**TECHNICAL BULLETIN**

**Product :** Midilift SL and Stairiser SX.

**Subject :** RCD installation detail.

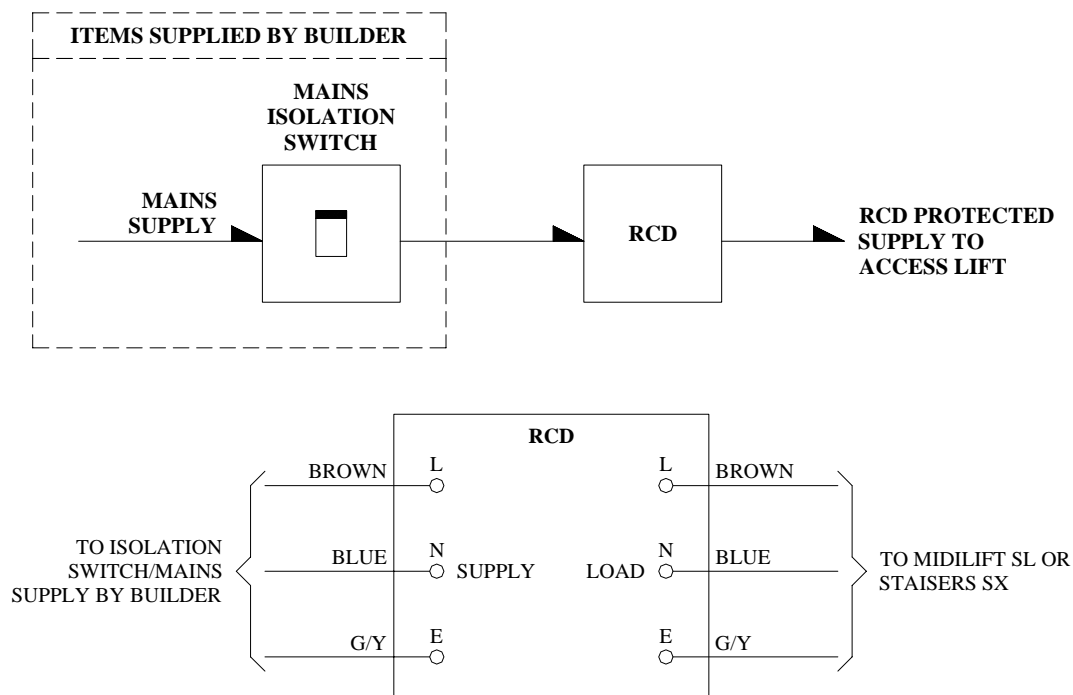
The following diagram indicates exactly where in the mains supply circuit that the RCD is to be installed (Note: the RCD must be mounted within close proximity of the lift) –

To reduce the high number of site revisits due to electrical supply problems, RCD's will now become van stock for all access installers. This will allow the installation and test procedure to be completed on sites where the builder has not fitted an RCD.
